**MAINTENANCE
INFORMATION**

MI13-06

DATE :	MAY 2013	SECTION :05-Cooling System
SUBJECT :	HOSE CLAMP FOR COOLING SYSTEM CONNECTION

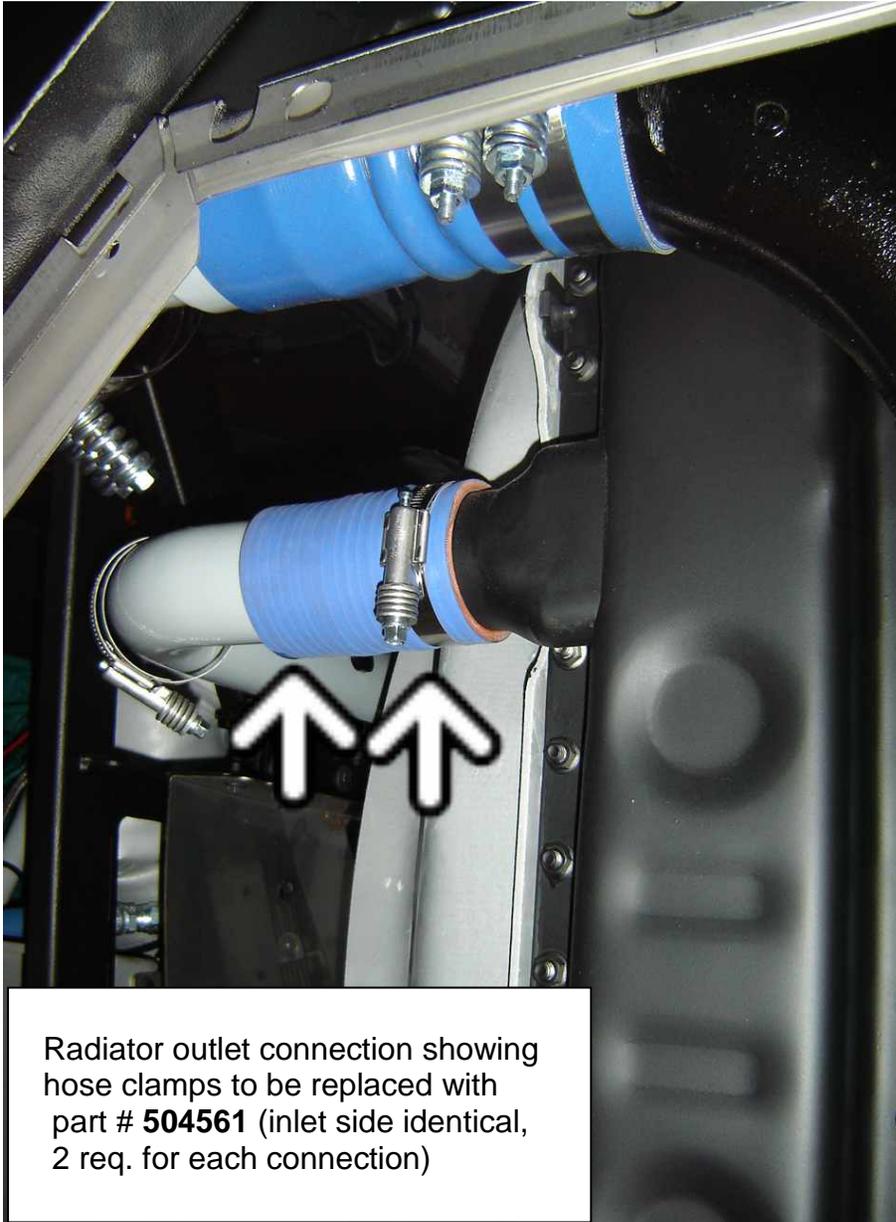
- 7- Replace the four (4) hose clamps on the blue flexible hoses located at the radiator inlet and outlet connection with four (4) new hose clamps (part # **504561**).

Figure 1

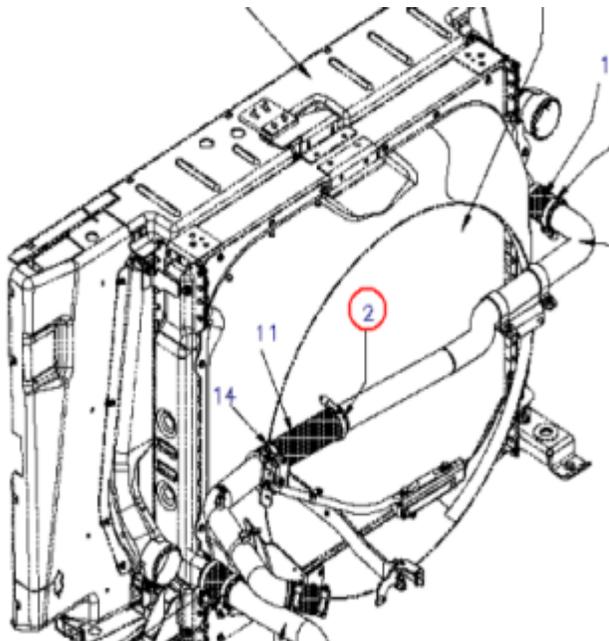
8- On the radiator connecting hose near the turbocharger, replace the hose clamp nearest to the radiator outlet (number 2 on figure 1) with a new hose clamp (part # **504561**).
